The Commission has issued the enclosed Amendment No. 5 to Facility Operating License No. DPR-31 and Amendment No. 4 to Facility Operating License No. DPR-41 for Turkey Point Nuclear Generating Units 3 and 4. These amendments include Change No. 17 to the Technical Specifications and are in response to your request dated November 5, 1974, and staff discussions.

ATTACHMENT TO LICENSE AMENDMENTS NO. 5 AND NO. 4
CHANGE NO. 17 TO THE TECHNICAL SPECIFICATIONS
FACILITY OPERATING LICENSES NO. DPR-31 AND NO. DPR-41
FLORIDA POWER AND LIGHT COMPANY
TURKEY POINT NUCLEAR GENERATING UNITS 3 AND 4
DOCKETS NOS. 50-250 AND 50-251

SAFETY EVALUATION BY THE DIRECTORATE OF LICENSING
SUPPORTING AMENDMENT NO. 5 TO LICENSE NO. DPR-31, AND
AMENDMENT NO. 4 TO LICENSE NO. DPR-41
(CHANGE NO. 17 TO TECHNICAL SPECIFICATIONS)
FLORIDA POWER AND LIGHT COMPANY
TURKEY POINT NUCLEAR GENERATING UNITS 3 AND 4
DOCKETS NOS. 50-250 AND 50-251

Figure 2.1-1. Reactor Core Thermal and Hydraulic Safety Limits, Three Loop Operation

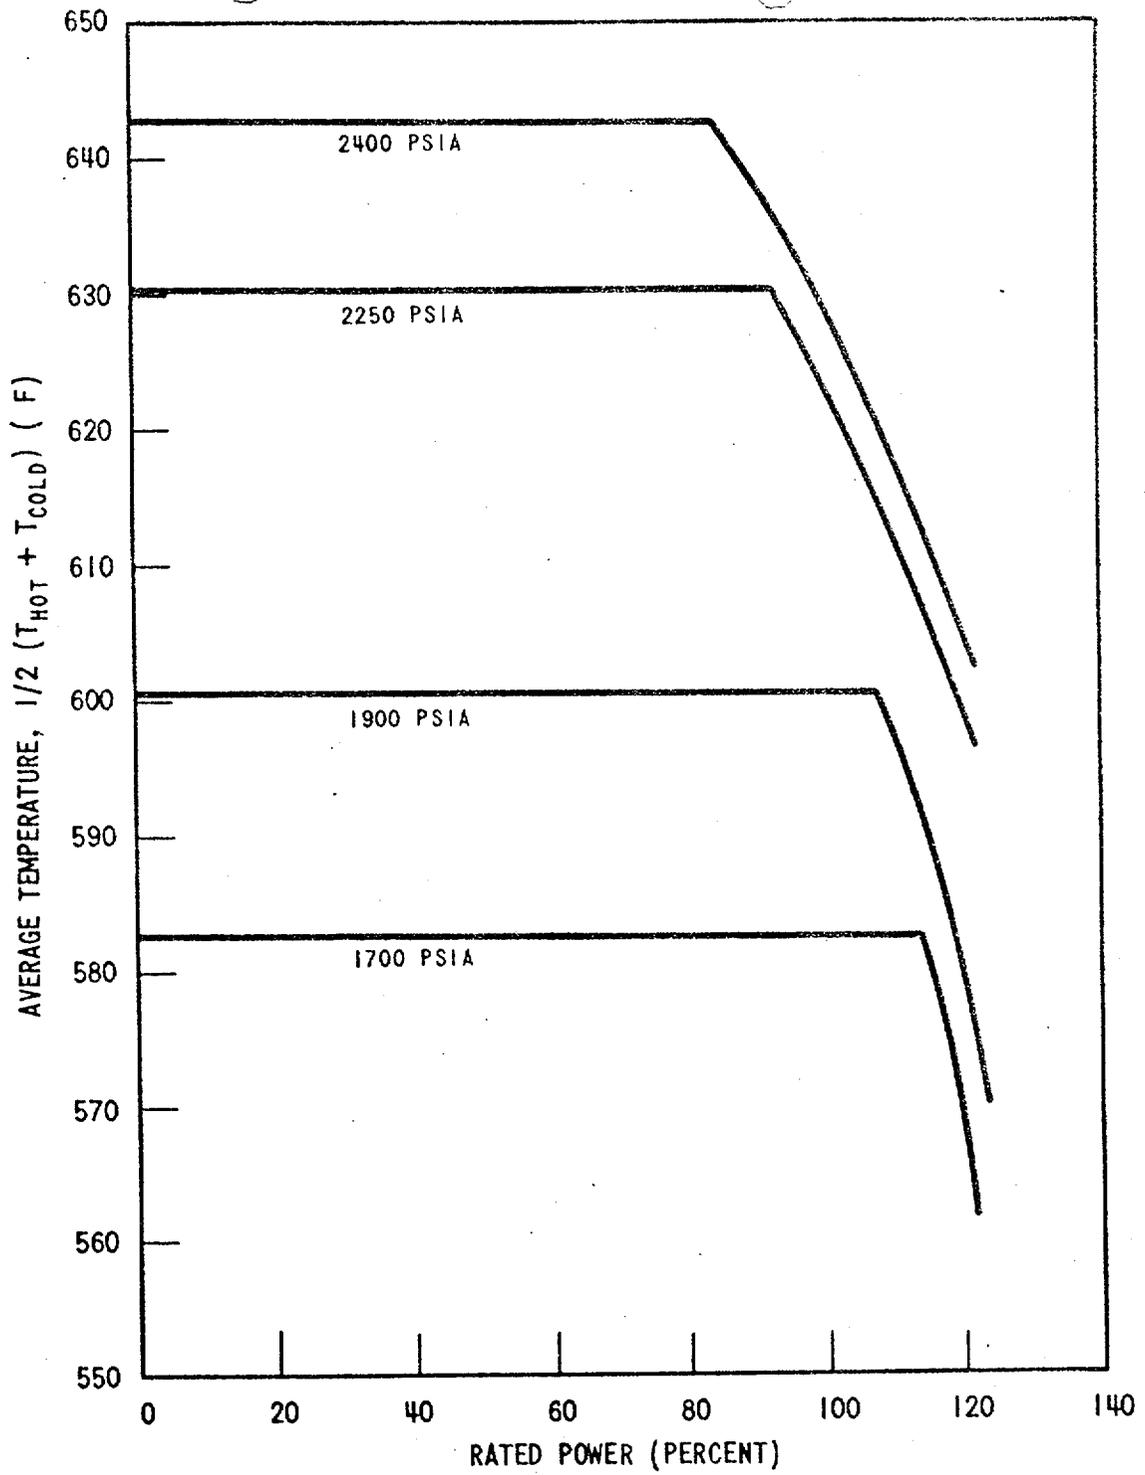
Revise Appendix A as follows: Replace page 1-6 and Figures 2.1-1 and 2.1-2 with the attached pages.

In order to make the present fuel residence limit applicable to Cycle 2, the references to Cycle 1 have been removed from the Technical Specifications figures which define core thermal and hydraulic safety limits for two loop and three loop operation.
